# UNITED STATES PATENT AND TRADEMARK OFFICE

APPLICATION NO.	FILING DATE	FIRST NAMED INVENTOR	ATTORNEY DOCKET NO.	CONFIRMATION NO.
10/787,429	02/26/2004	Joseph D. Rippolone	67067-012	4762
26096 7590 11/16/2007 CARLSON, GASKEY & OLDS, P.C. 400 WEST MAPLE ROAD SUITE 350 BIRMINGHAM, MI 48009			EXAMINER GILBERT, WILLIAM V	
			ART UNIT 3635	PAPER NUMBER
			MAIL DATE 11/16/2007	DELIVERY MODE PAPER

<b>Office Action Summary</b>	Application No. 10/787,429	Applicant(s) RIPPOLONE, JOSEPH D.	
	Examiner William V. Gilbert	Art Unit 3635

**DETAILED ACTION**

Figure 5 from Bortugno

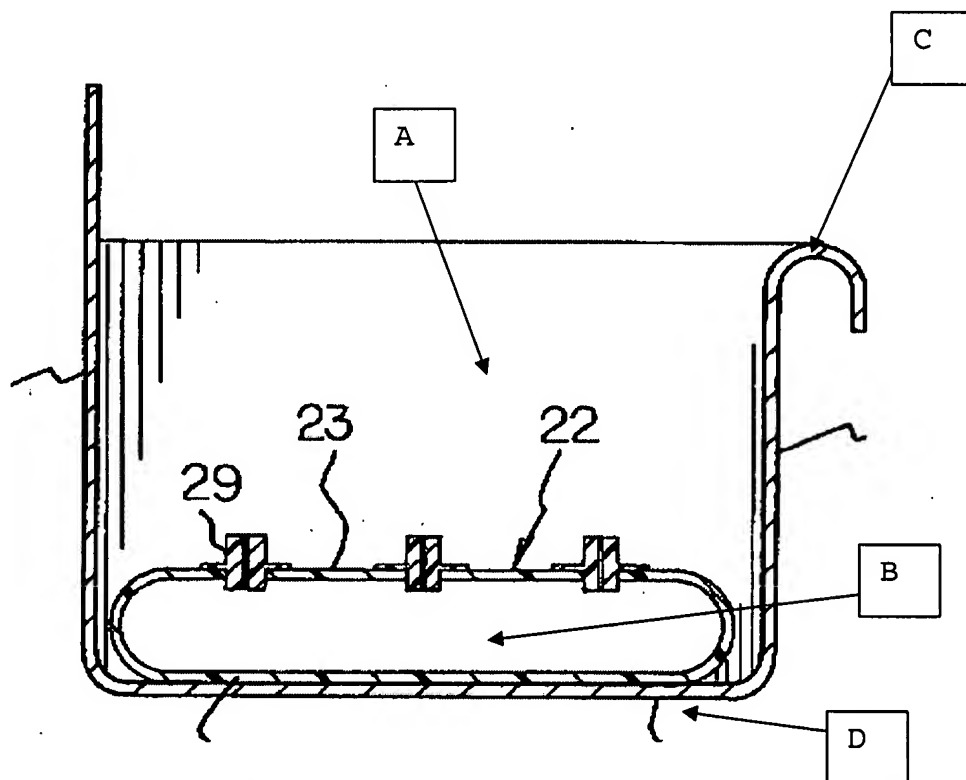
Independent Claim 12: Bortugno discloses a gutter section having a gutter section with a liquid passage (see "A" from attached Fig. 5 from Bortugno below) an air flow passage ("B" below), a gutter wall separating the liquid passage and the air flow passage, the gutter wall has two spaced apart side walls

(16) and a bottom wall (23) that define the liquid passage, and the air flow passage extends through the bottom wall (see portion 29 that extends through the bottom wall (23)). Applicant should respectfully note that the limitation "molded" line 1 indicates method steps and only the final product, the gutter section, is provided with patentable weight.

Claim 2: the air flow passage extends within the bottom wall (see portion 29).

Claim 13: the airflow passage is parallel to the liquid flow passage (see Fig. 5, generally).

Claim 14: the gutter wall is common wall (portion 23) that at least partially defines the liquid passage and the airflow passage.

Claim 15: the gutter wall (portion 16) includes a solid body extending between a continuous upper surface ("C" above) and a continuous lower surface ("D" above).

Claims 7 and 8: Bortugno discloses a gutter thawing system (Fig. 5) having a gutter section with a liquid passage ("A" above) and an air flow passage ("B" above) and a hot air supply (12). Bortugno does not disclose multiple of air flow passages or a multiple of gutter sections. It would have been obvious at the time the invention was made to a person having ordinary skill in the art as a matter of duplication of parts to have this limitation because duplication of parts has no patentable significance unless a new and unexpected result is produced. *In re Harza*, 274 F.2d 669 (CCPA 1960). See MPEP §2144.04. Further, Bortugno discloses the air passages as linear, but not
